Thank you for the opportunity to comment on the Hunua Quarry Development substantive application [FTAA-2603-1185] under the Fast-track Approvals Act 2024 (FTAA).

MEMORANDUM OF PLANNING MATTERS FOR AUCKLAND COUNCIL

1. This Planning Memorandum (**Memorandum**) sets out Auckland Council’s statutory planning assessments of the Substantive application for the Hunua Quarry Development project (**Application**) lodged by Winstone Aggregates (**Applicant**) under the FTAA, and a summary of assessment outcomes and proportionality conclusions.

Figure 1: Aerial image showing subject site (outlined in yellow) and area of concern raised by Auckland Transport (red).

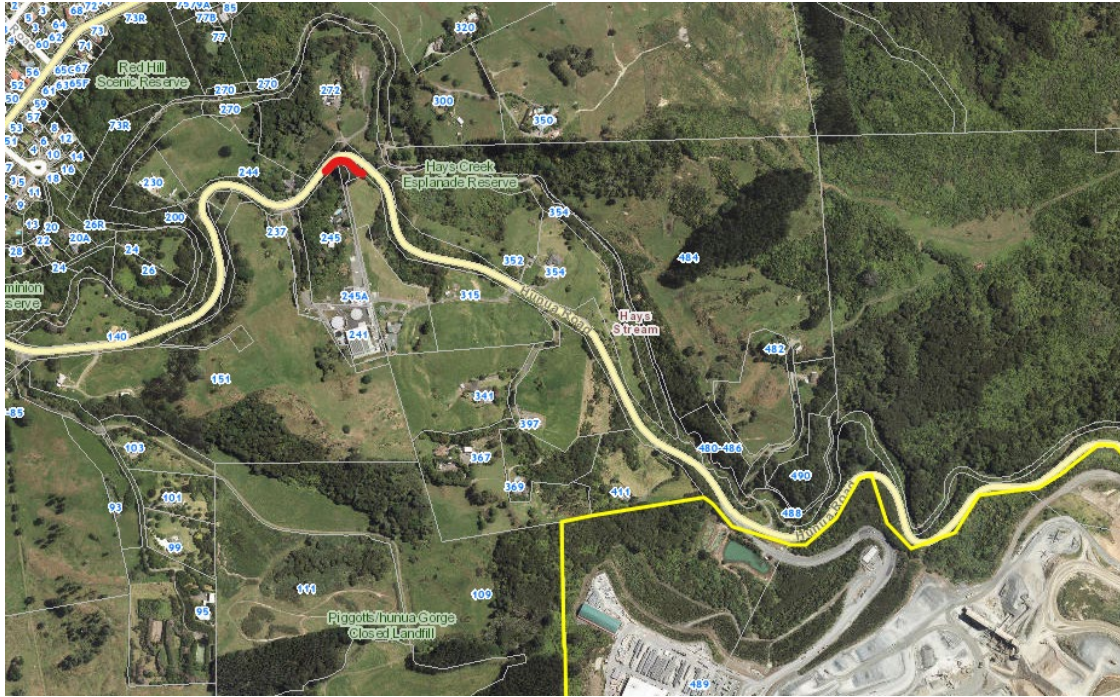
85. Auckland Transport (**Annexure 4**) are generally in agreement with the Applicant with respect to effects on the roading network. However they have an outstanding concern with respect to roading safety at the corner on Hunua Road identified in red in Figure 1 below:

86. Auckland Transport are of the opinion that the crash history indicates an inherent safety trend and concern that will be exacerbated by the increased trip generation arising from the proposed development. It is understood that there are two serious injury crashes of concern (in 2023 and 2025) caused by a vehicle crossing the centre line at this bend.

Image 1: Google street view at the bend.

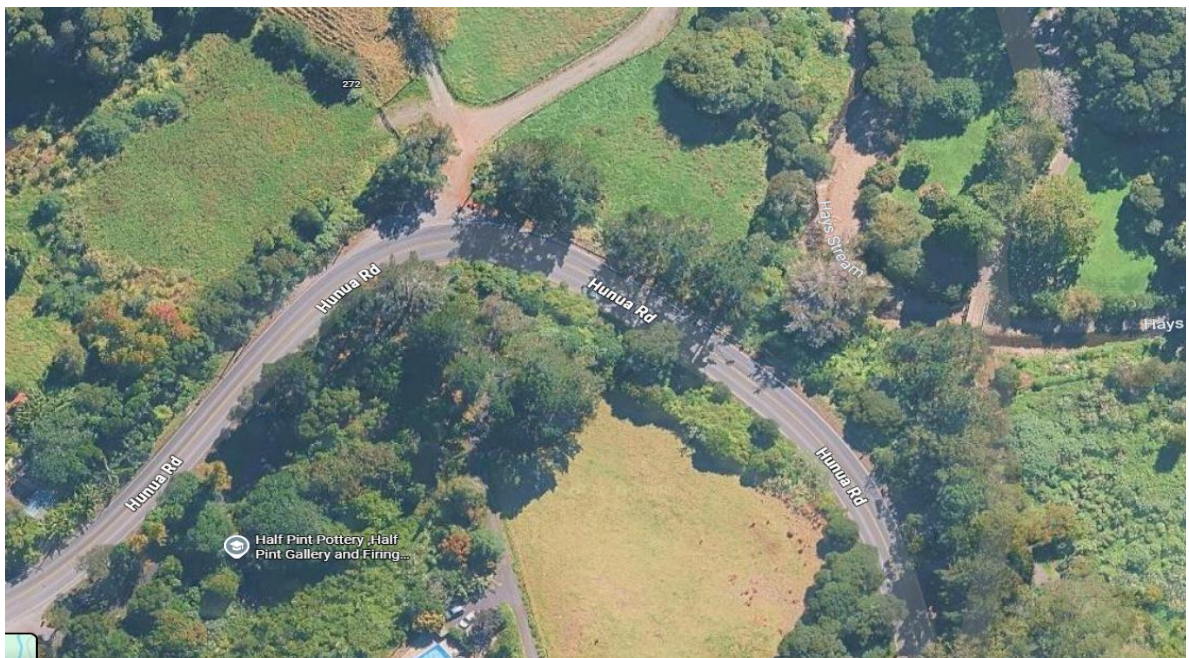
The applicant has proposed installing ATP along the centreline of the carriageway at the Hunua Road bend as a mitigation measure to discourage vehicles from crossing the centreline.

A meeting was held with the applicant on 4th June 2026 to discuss the traffic matters raised by AT. AT and the applicant's representatives were generally in agreement with AT's recommended conditions and advice notes, except in relation to the proposed road improvement works at the existing bend.
